**MAINE TURNPIKE AUTHORITY**

**ADDENDUM NO. 1**

**REQUEST FOR PROPOSALS S2009.55**

**WEST GARDINER TRAVEL PLAZA**  
**TRUCK STOP ELECTRIFICATION SYSTEM**

CONDUIT TRENCH DETAIL

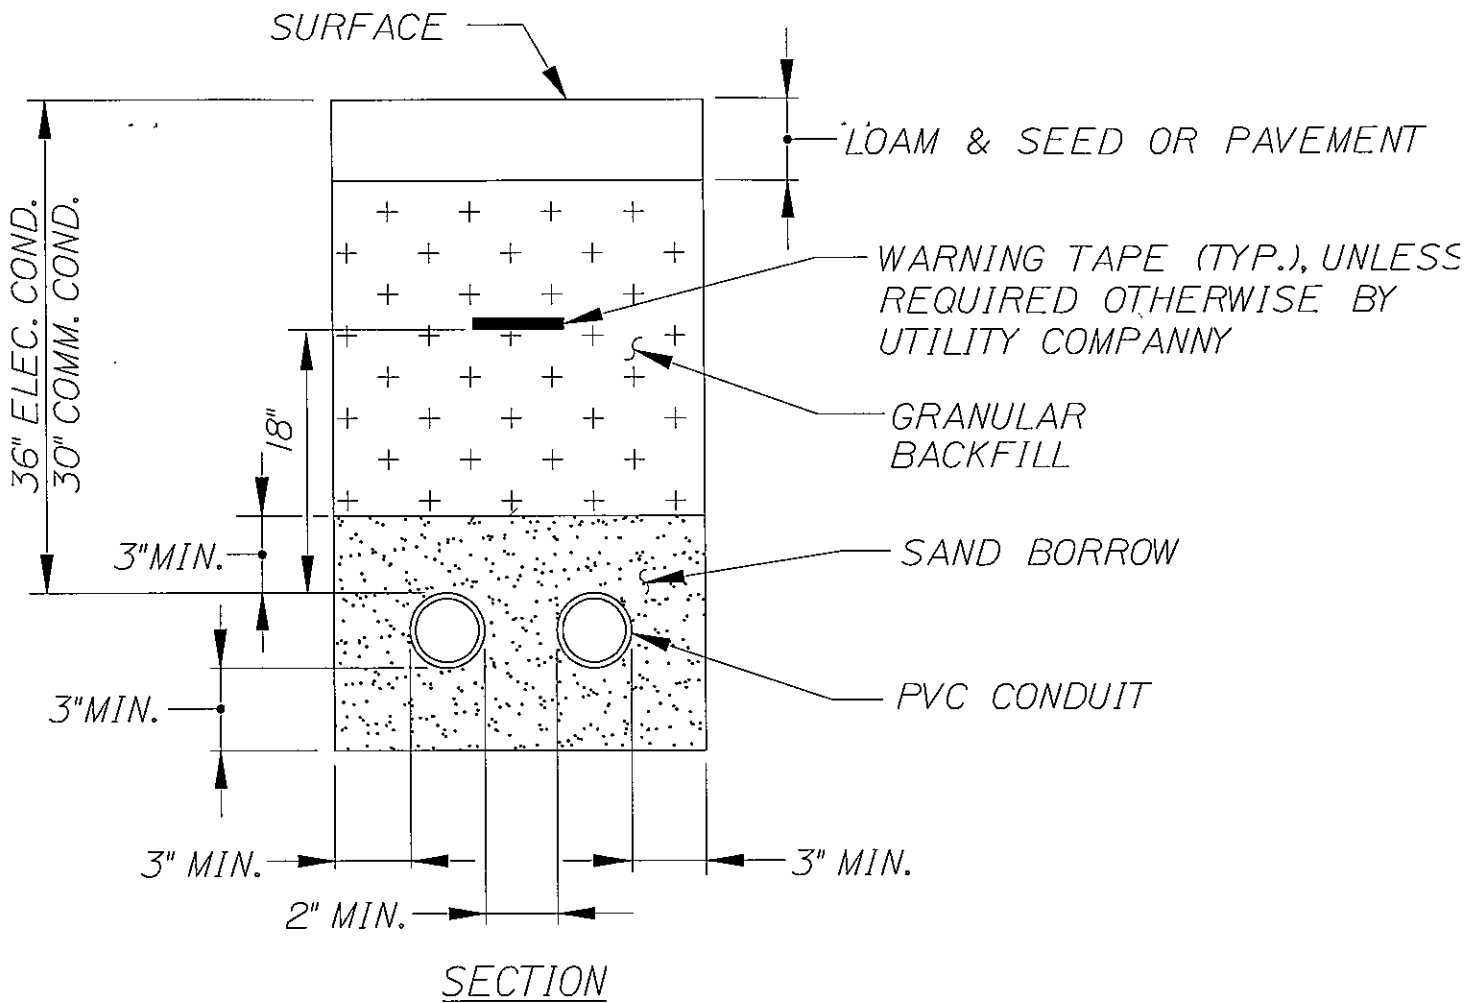
Question 6: Is there an MTA or Maine DOT standard conduit trench detail that will be utilized for this project? If so, can we be provided with a copy of this or be directed to where we can obtain this detail? Are there any MTA or MaineDOT standards or restrictions regarding placing power and communications conduits within the same trench? If so what are they?

Answer: The attached MTA standard trench detail is included in this addendum for information only. It is the MTA's assumption that RJ Grondin (RJG) will be installing all conduits below finished grade. Power and communication conduits can occupy the same trench as long as it is in compliance with the NEC. Conduit spacing shall meet code requirements. MTA understands that the conduit location,

size, number, and construction details may be revised based on the selected vendor's design. MTA will coordinate this work with RJ Grondin as warranted.
